Service Kit

753-0840

CODE: T-144

SUBJ: Speed selector assembly

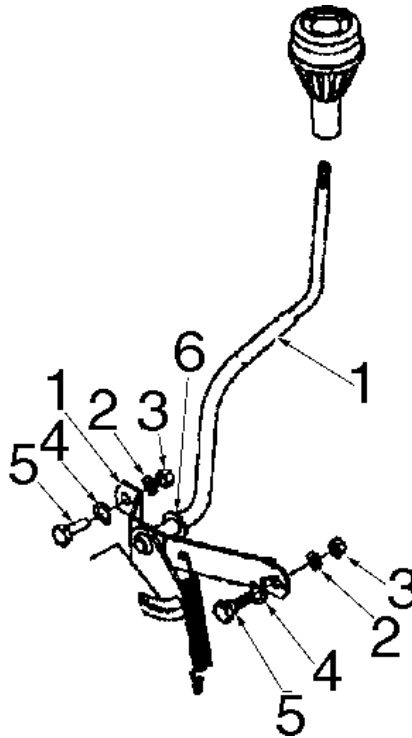
Install Service Kit 753-0840 when replacing speed selector lever assembly part number 16906.

When installing replacement speed selector lever assembly it will be necessary to drill an additional hole in the frame for proper installation. Location of the hole to be drilled can be determined by installing the speed selector in the frame and secure with hardware provided in kit. Install one shoulder bolt, washer and nut in the front portion of the selector bracket (see Diagram) and secure. Mark the location of the rear mounting hole and drill with 5/16" drill bit. Install remaining shoulder bolt, lock washer, and nut and secure.
